21 May 2025

OUR REF: EXTERNAL/2024/0010

**Inner West Council Response: SSD-69377980 – Maronite Sisters of the Holy Family –
Village 1 at 194-210 Wardell Road and 46 Pine Street, Marrickville**

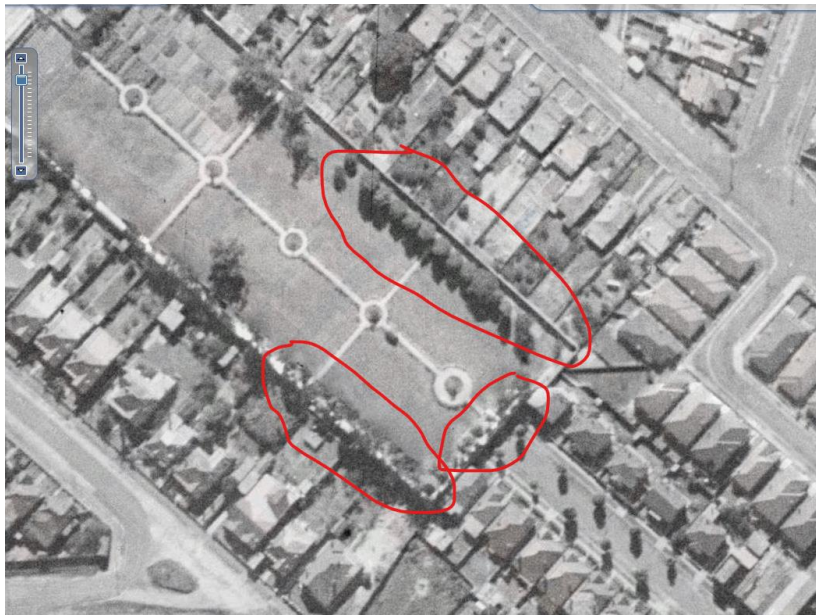
Trees are an important element of the landscape setting, and a number of the buildings contribute to the heritage status of this site. Brushbox trees in particular are significant and early aerial image (below) attests to their contribution at the perimeter and adjacent to the north-eastern section of the boundary wall. Given their significance further information is sought about the reason for the proposed removal of trees and a more detailed landscape plan is required to demonstrate where replanting will occur. This is to ensure the species of trees restore the canopy cover in a manner which is also consistent with the heritage contribution trees have made to this site. Justification of tree removal is required to satisfy the provisions of Part 2.20 – Marrickville Development Control Plan 2011.

Investigation of an alternate location of the electrical kiosk is required in order to mitigate the impact on existing trees along the perimeter.
